SUBJECT: ON Semiconductor Final Product/Process Change Notification # 16361

TITLE: Addition of ON Semiconductor Gresham Fab for CAT24C02 2K-bit I²C Serial EEPROM

SOIC 8 (W)

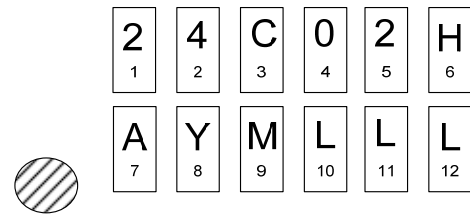
Current Marking: OKI die

FRONT SIDE MARK:

- 1: Assembly location code
- 2: Mark "4" for (lead finish NiPdAu)
- 3: Product Revision: Fixed as "G"
- 4-9: Product Name: "24C02W"
- 10: Temp Range (I=Industrial; E=Extended)
- 11: Production Year (last digit)
- 12: Production Month (1-9, A,B,C)
- 13-16: Last four digits of assembly lot number

FRONT SIDE MARK:

- 1-5: Device Code "24C02"
- 6: Product Revision - Fixed as "H"
- 7: Assembly Location
- 8: Production Year
- 9: Production Month
- 10-12: Lot Number

PDIP 8 (L)

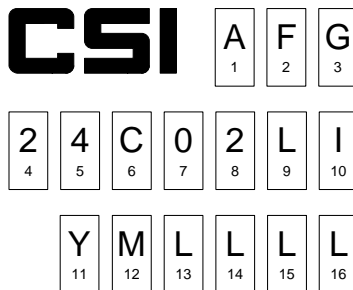
Current marking: OKI die

FRONT SIDE MARK:

- 1: Assembly location code
- 2: Mark "4" for (lead finish NiPdAu)
- 3: Product Revision: Fixed as "G"
- 4-9: Device Code: "24C02W"
- 10: Temp Range (I=Industrial; E=Extended)
- 11: Production Year (last digit)
- 12: Production Month (1-9, A,B,C)
- 13-16: Last four digits of assembly lot number

Gresham die

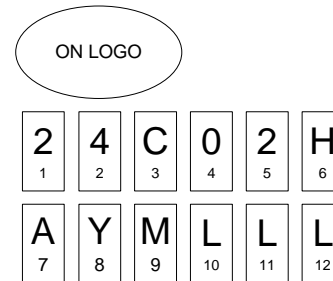
FRONT SIDE MARK:

- 1-5: Device Code "24C02"
- 6: Product Revision
- 7: Assembly Location
- 8: Production Year
- 9: Production Month
- 10-12: Lot Number
